Architect's Supplemental Instructions Addendum

Project: Samish Xwch'ángteng Development on 34th Street
Anacortes, WA

Addendum/ASI No.: Addendum 03
Date of Issuance: May 23th, 2022

COMMUNITY CENTER
HVAC PLANS

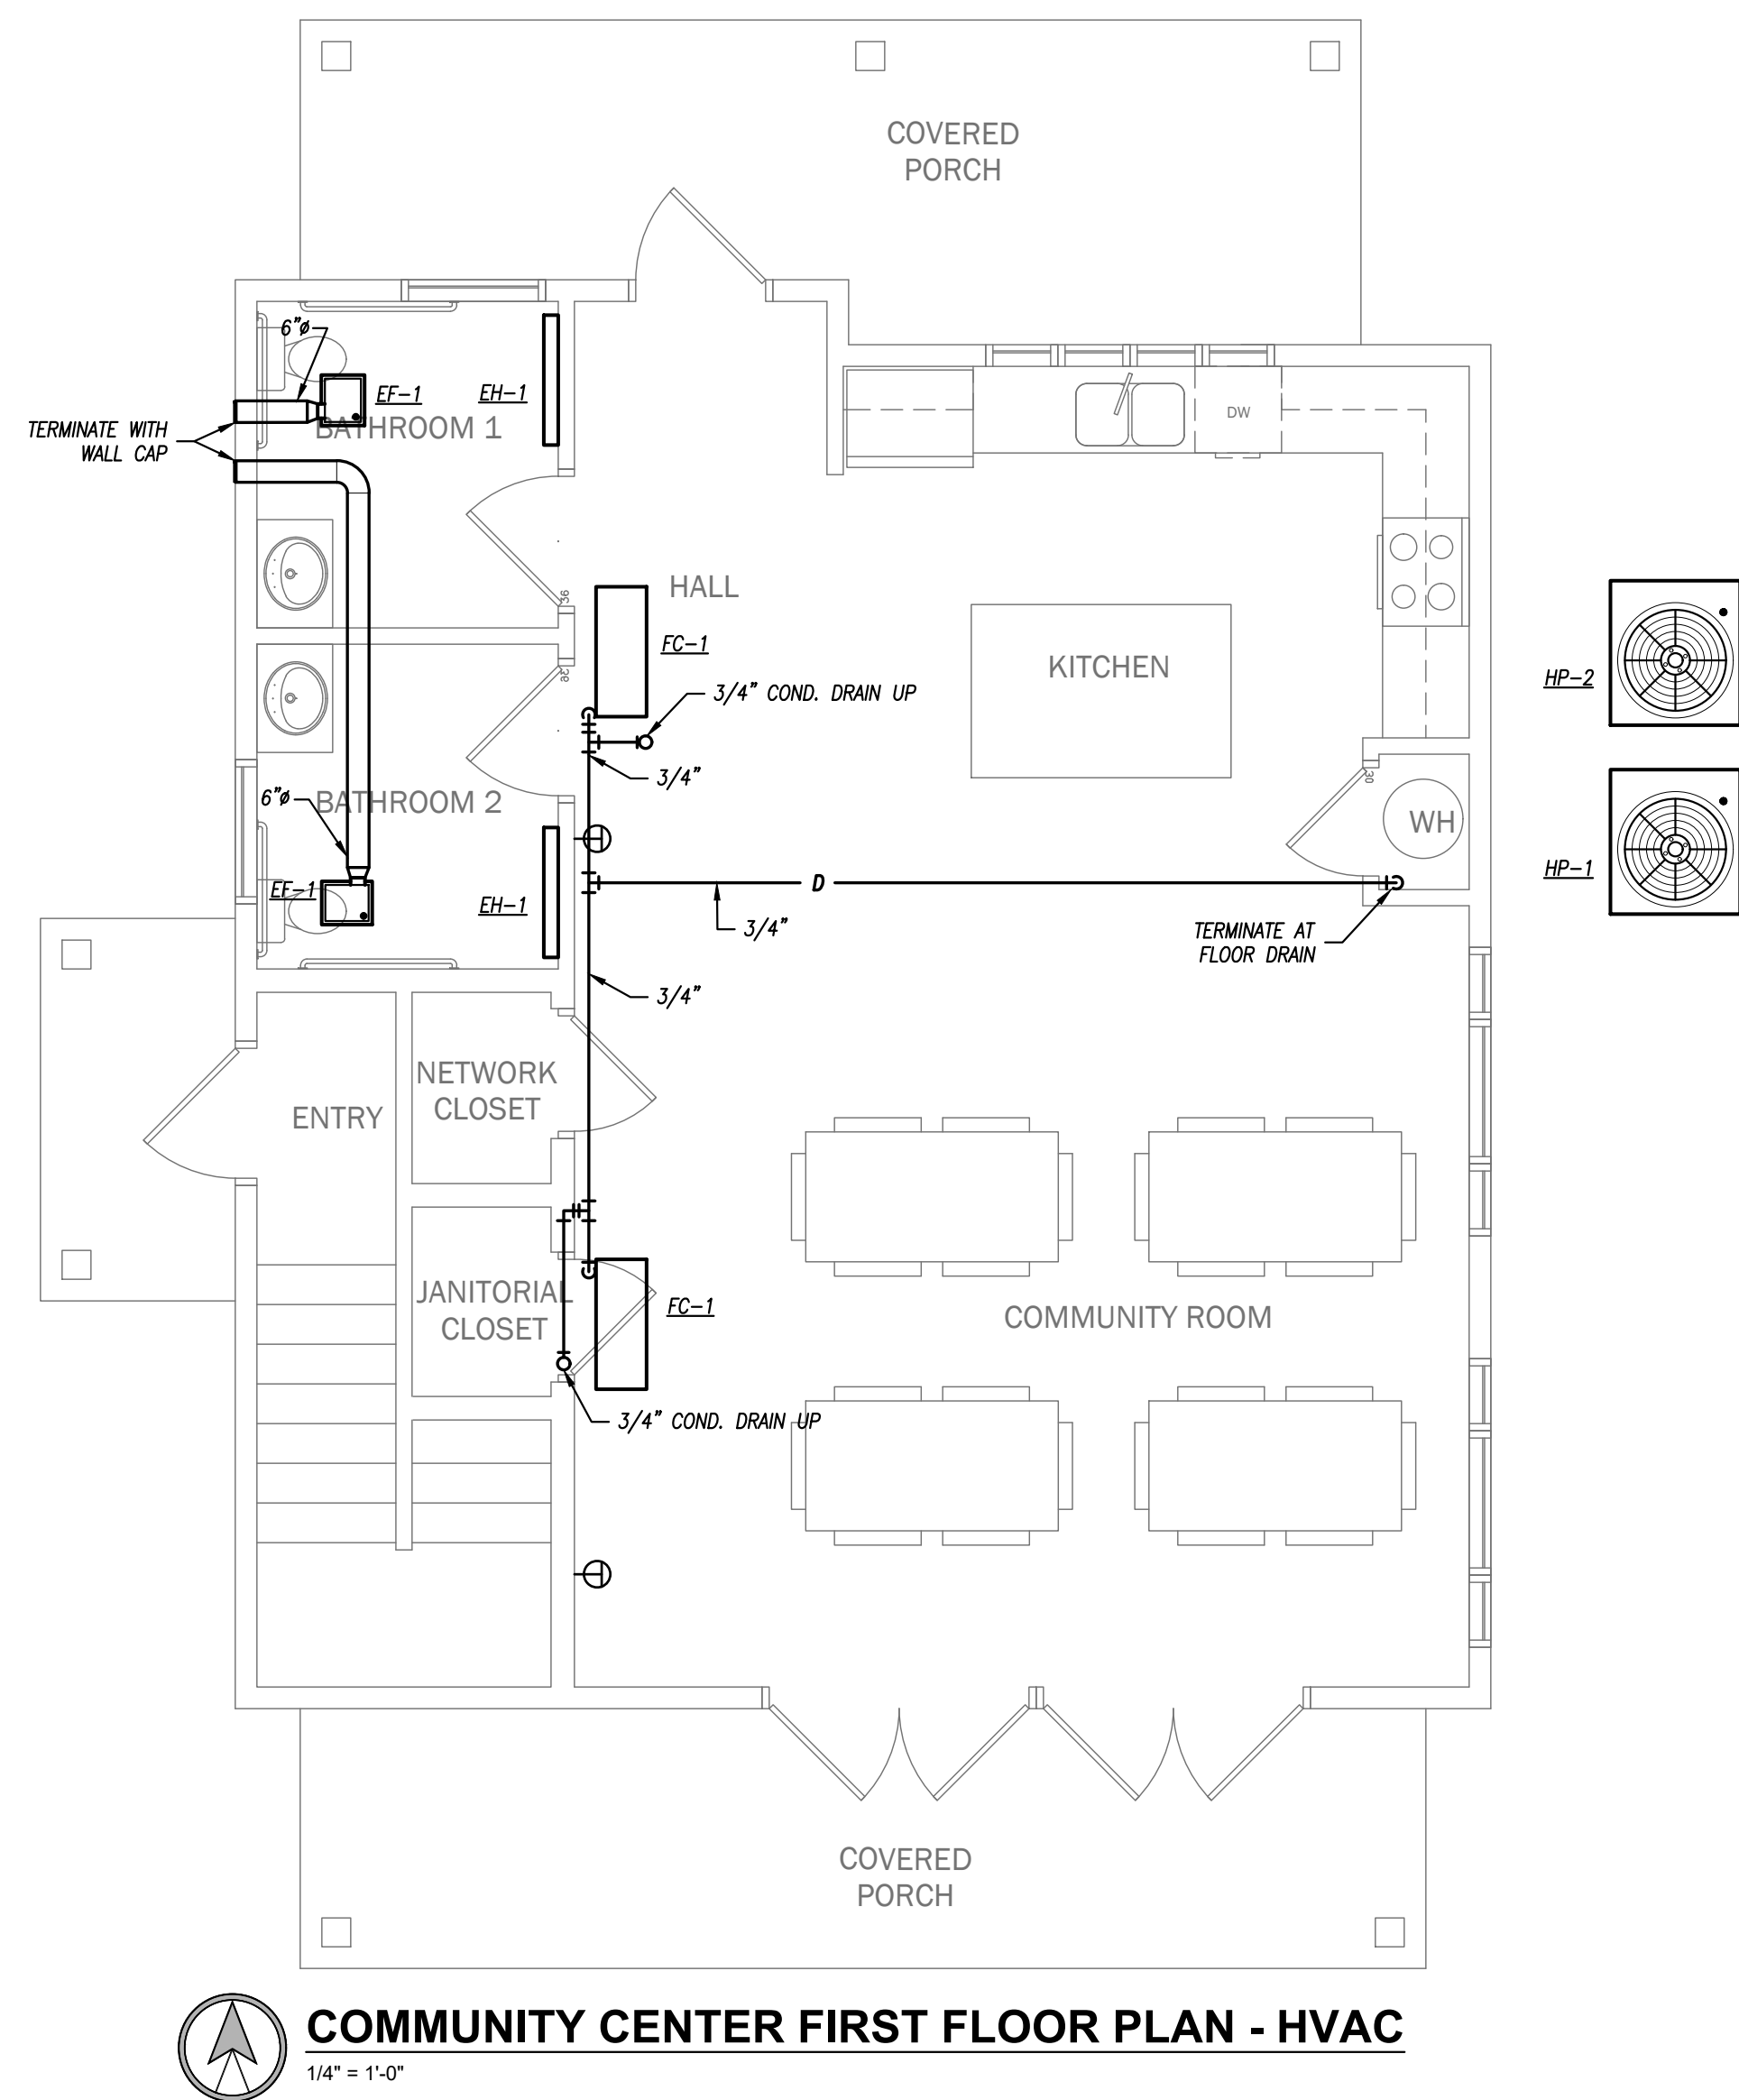
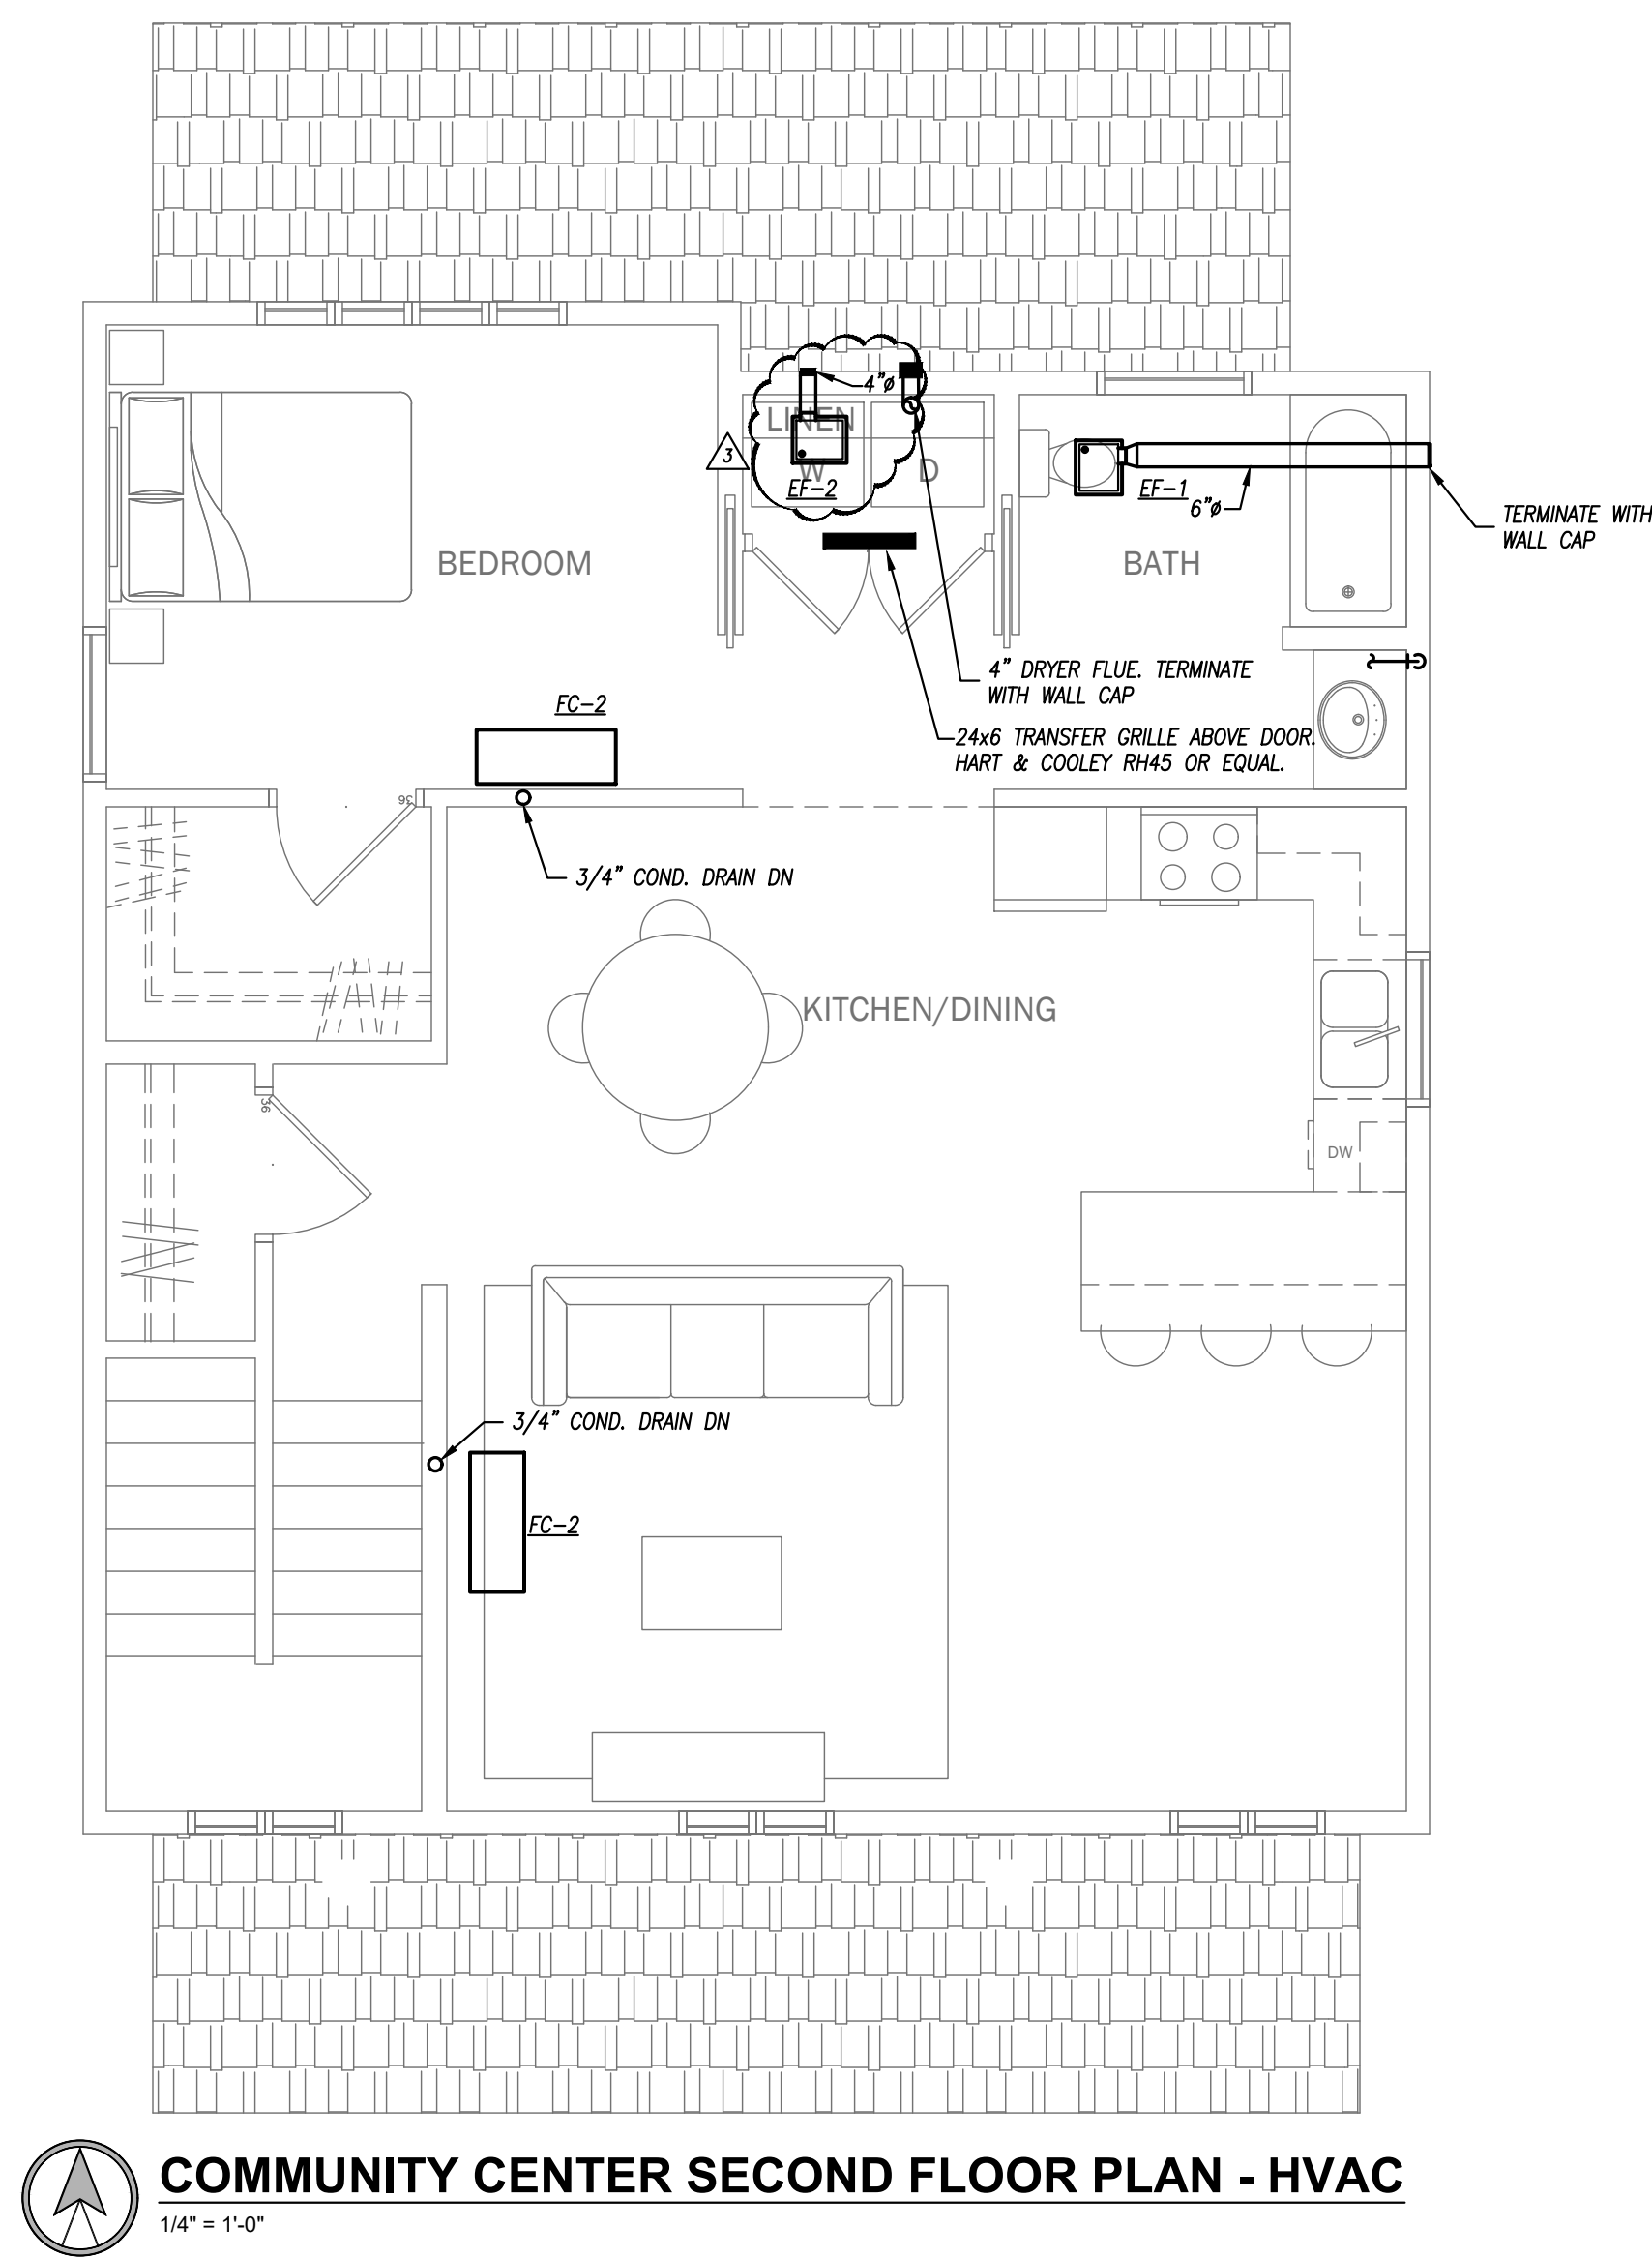
29. City of Anacortes Approved set comments M-101, M102: **50 cfm vent fan required in laundry closets.** [See revised sheets M-101, M-102, M-201](#)
30. City of Anacortes approved set comments ATS: **Energy credits table added to cover sheet** [see general note #19](#)

10. Sheet M-101 **ADD EXHAUST FAN**
11. Sheet M-102 **ADD EXHAUST FAN**
12. Sheet M-201 **ADD EXHAUST FAN**
13. Sheet E-101 **ADD DOOR CHIME**
14. Sheet E-102 **ADD DOOR CHIME**

COTTAGE POWER
PLANS

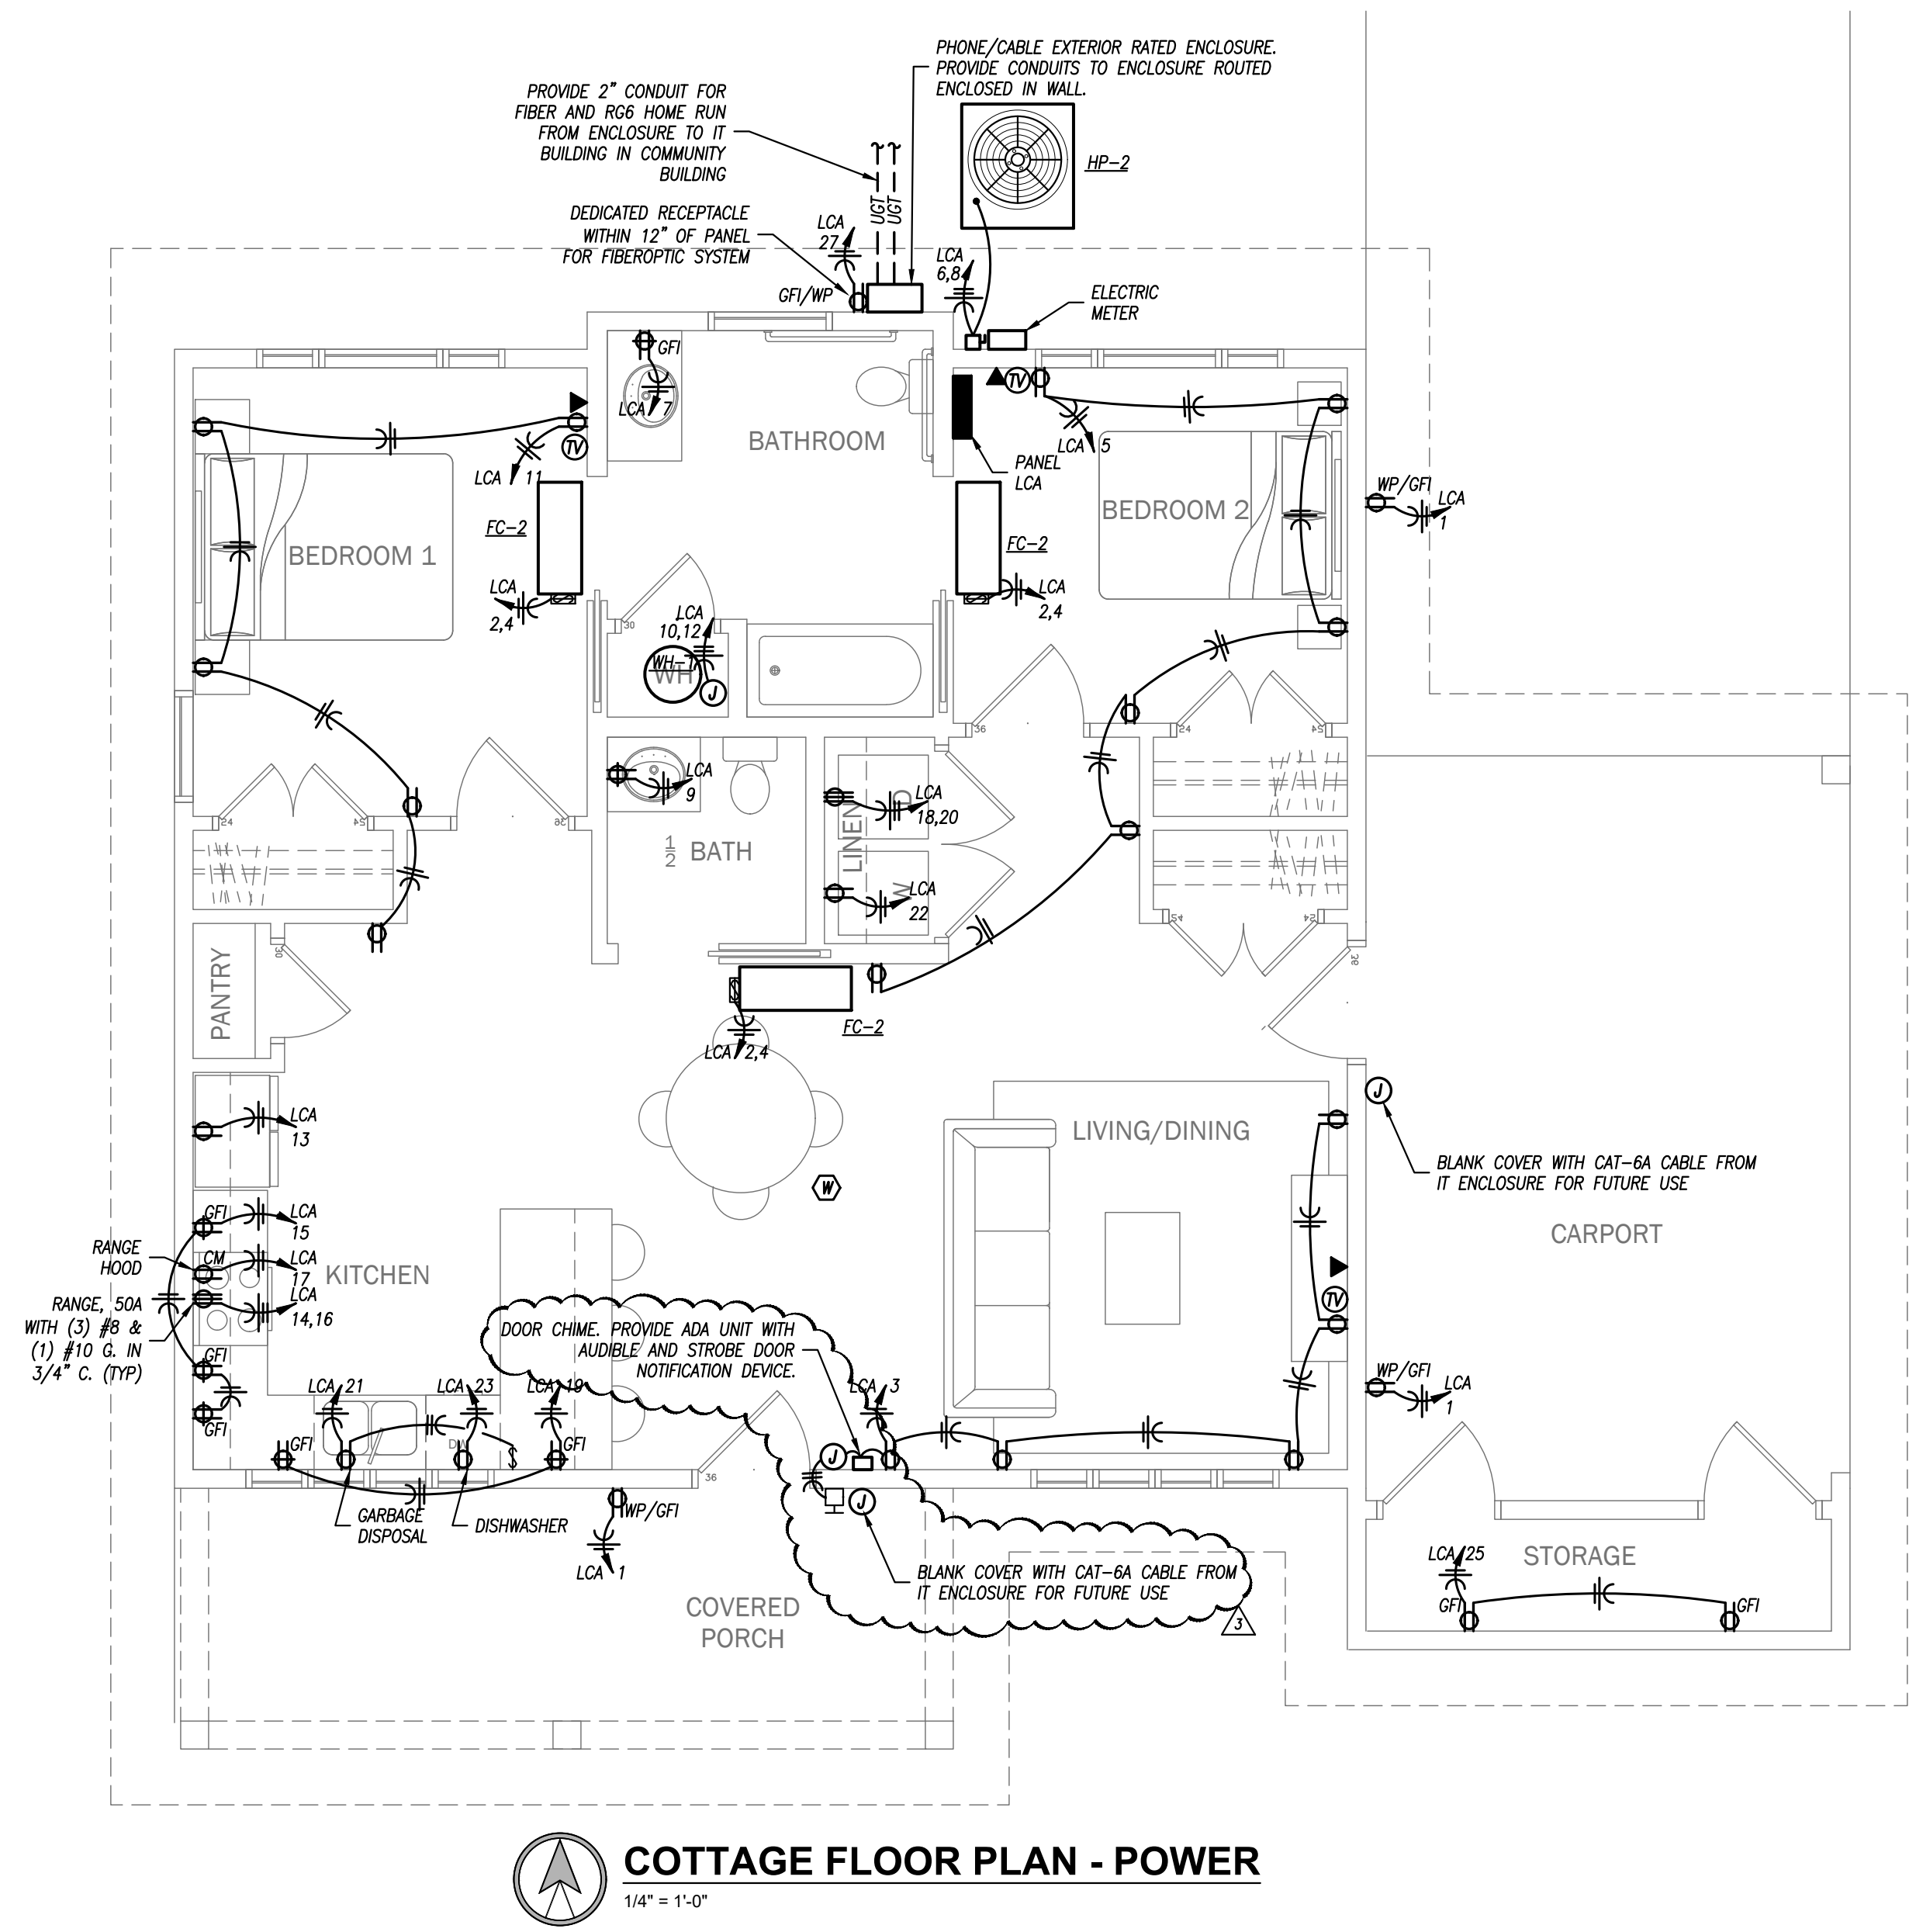
20. Please define what the sensory unit requires or where we can find the information. [It is referenced in the building code 2009 ICC A117.1 Section 1006. Smoke Alarm information is noted Sheet E-401 Section 16600 – Smoke Alarm D. See attached revised sheet E-101 & E-102 Door chime & Strobe](#)
